TITLE	REV.	DATE	DRAWN	M.T.	CHECKED	APPR.
008	PRELIMINARY ISSUE	06.12.10		N.M.			
132KV TRANSMISSION LINE ROUTE FOR E.A.R. BP SOLAR FLAGSHIPS FACILITY MOREE, NSW							
	DRAWING	CNO.	CIRD	ASPER	1 OF 1		
	VENTIC	DATE	DATE	DATE	REV.		
	02.12.10				008		
	CDO REF:	VEMCOM119A/MOREE	SHEET SIZE:	A1			
	SYMBOL:	MCOT11119

RE: Transmission Line Corridor Study Enquiry for the FRV-BP Solar 180MWdc Solar Flagships Project

**Letter of Support - Transmission Line Corridor Study Enquiry for FRV-BP Solar 180MWdc
Solar Flagships Project**

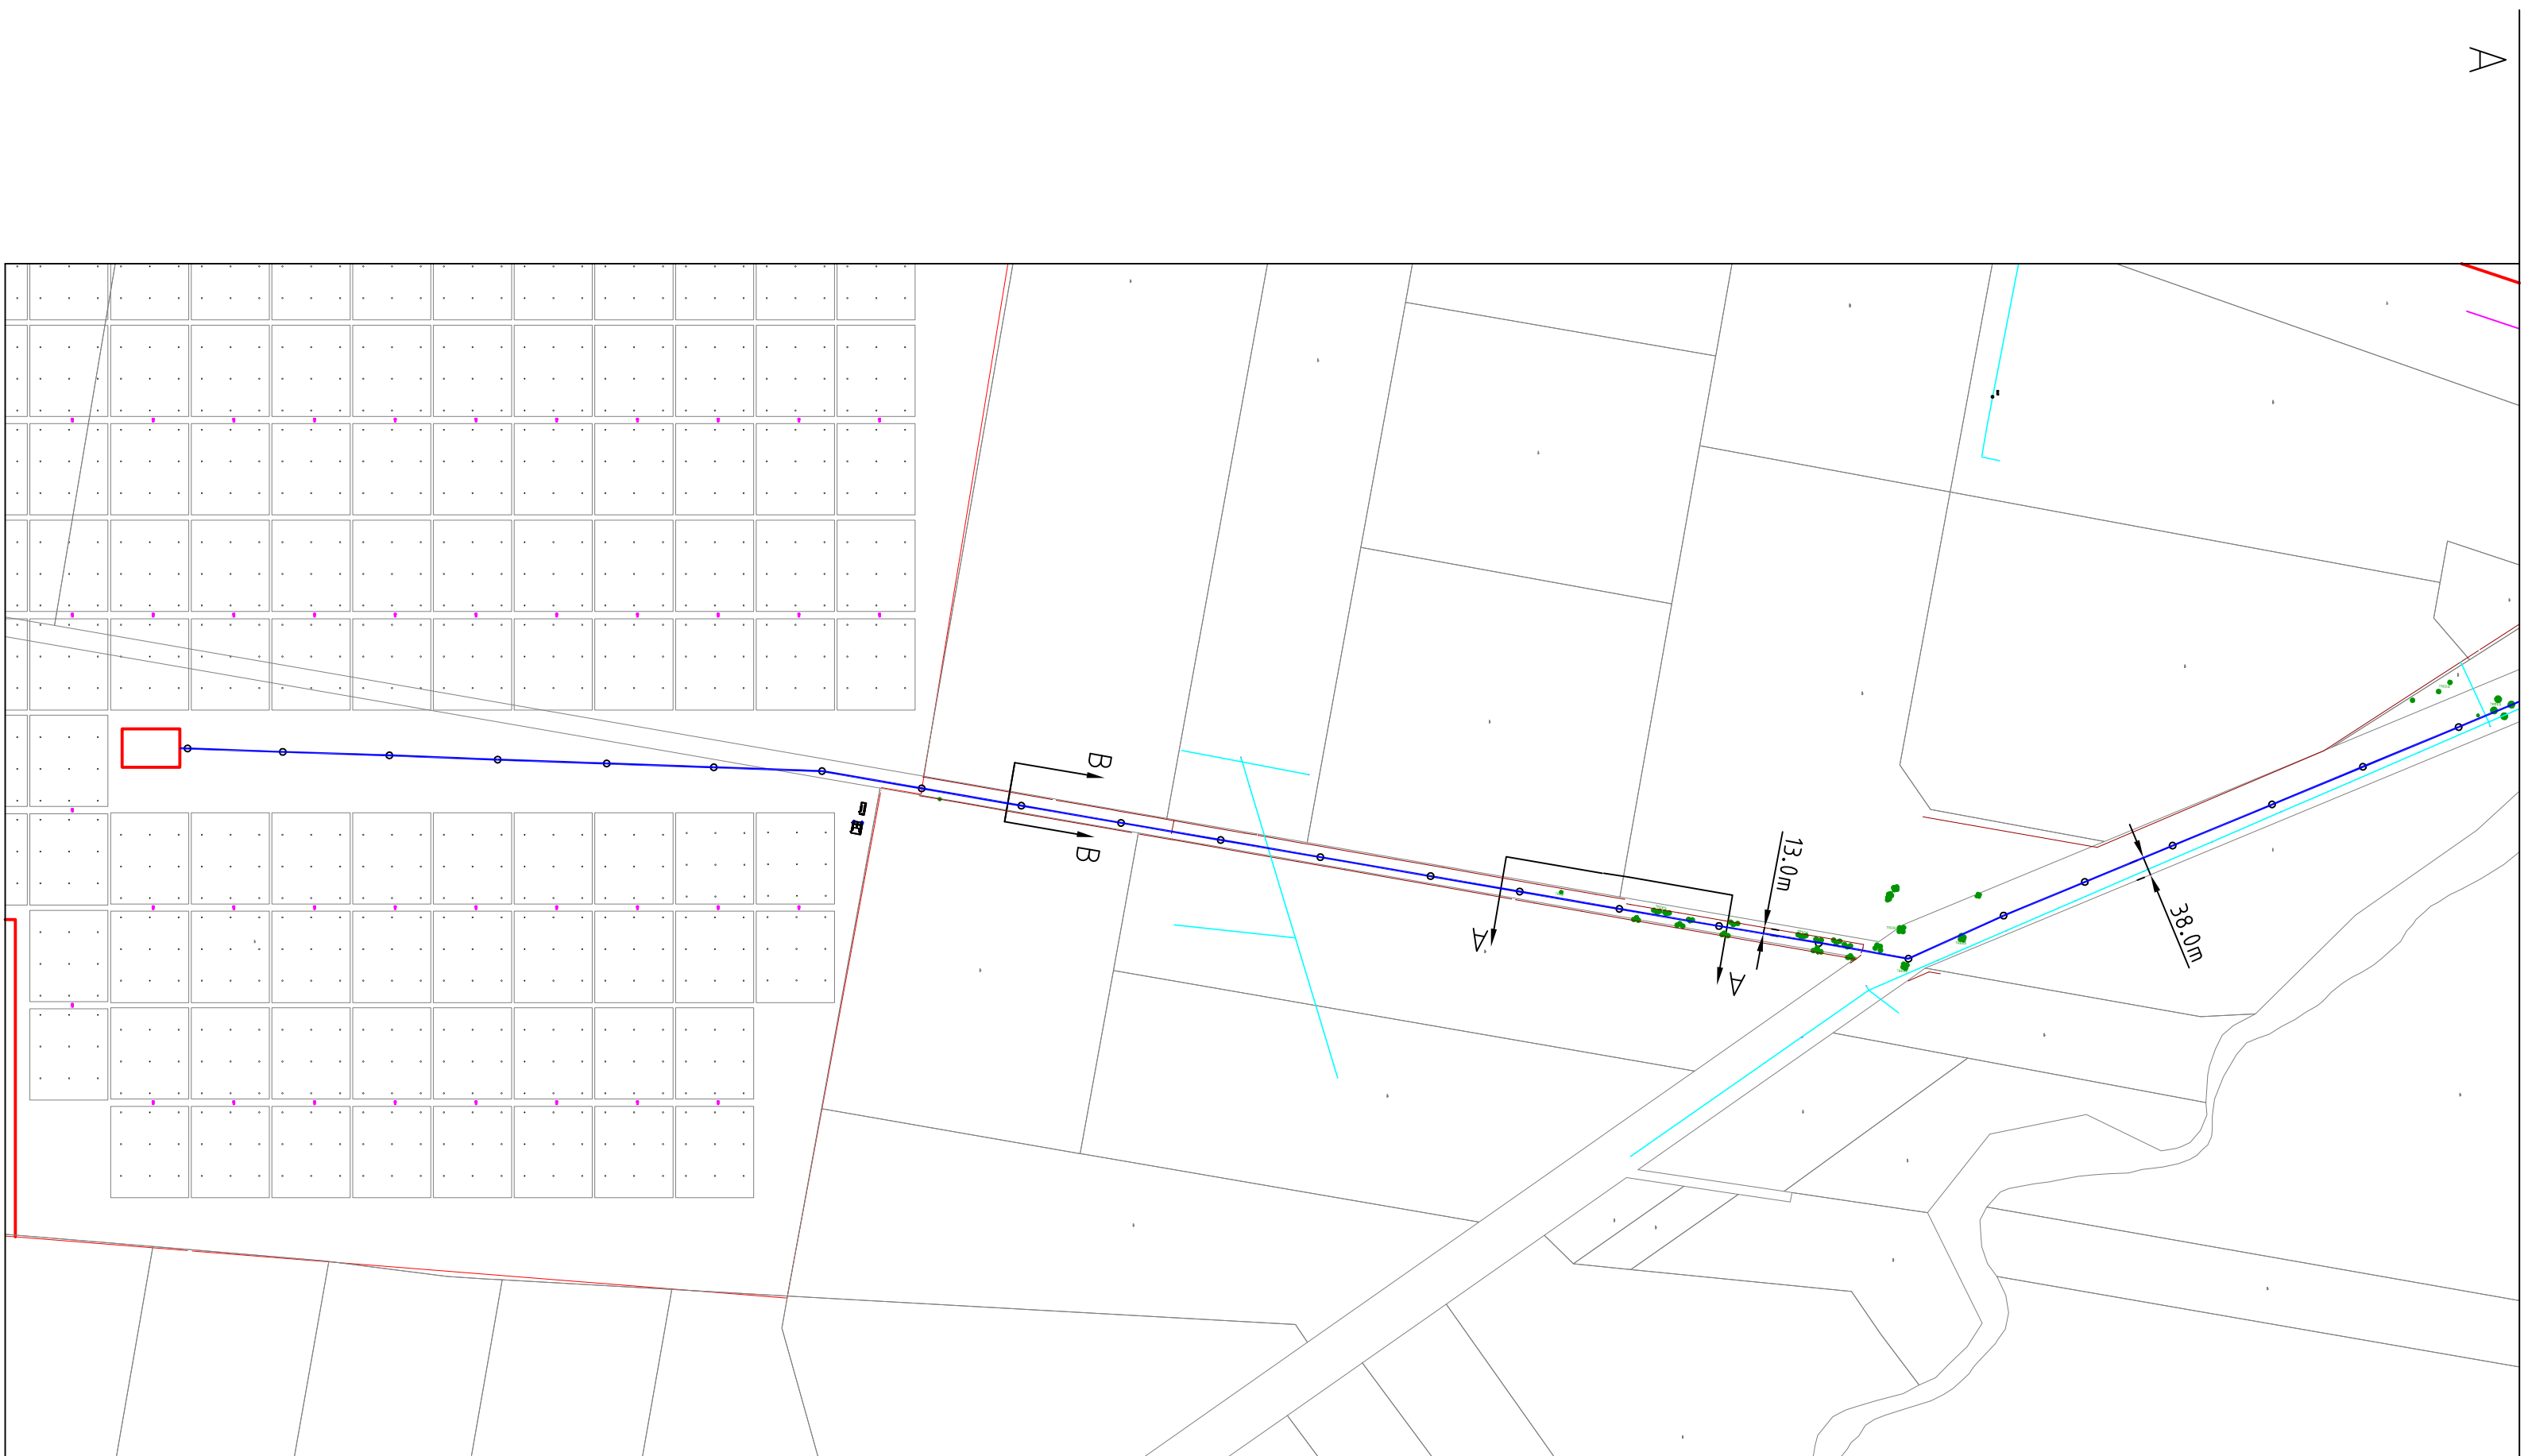
I refer to your letter of 2 December 2010 and wish to advise that although the proposed route of your 132kV line generally follows the road network as constructed there appears to be deviations of this from the legal public road reserve. This would need to be clarified by a registered surveyor.

In general I agree with the proposed route as being very feasible and in driving the route have made the following observations:

1. The section between Bullus Drive and Industrial is on top of an existing open trunk storm-water drain. This would need to be piped for 800 metres long to allow for the installation of poles.
2. The section from Tycannah Street near Manildra Grain South to the connection with Burrington Road requires a boundary survey to establish the legal public road reserve bounds.
3. The gravel section of Barton Plains Road accessing the proposed site would require slight shift to the west.

SMK should be able to validate whether the proposed route lies completely within the public road reserve for which Council is the road authority.

I refer to your letter dated 7 December 2010 and note that your Consortium commits to undertaking additional survey work and consultation with MPSC post 15 December to meet the technical and feasibility requirements identified in our letter dated 6 December 2010.

On the basis of your commitment (as summarised above), I am pleased to advise that Moree Plains Shire Council confirms the subsequent feasibility and conditional support for this transmission line and agrees to the transmission line being routed on the public road reserve.
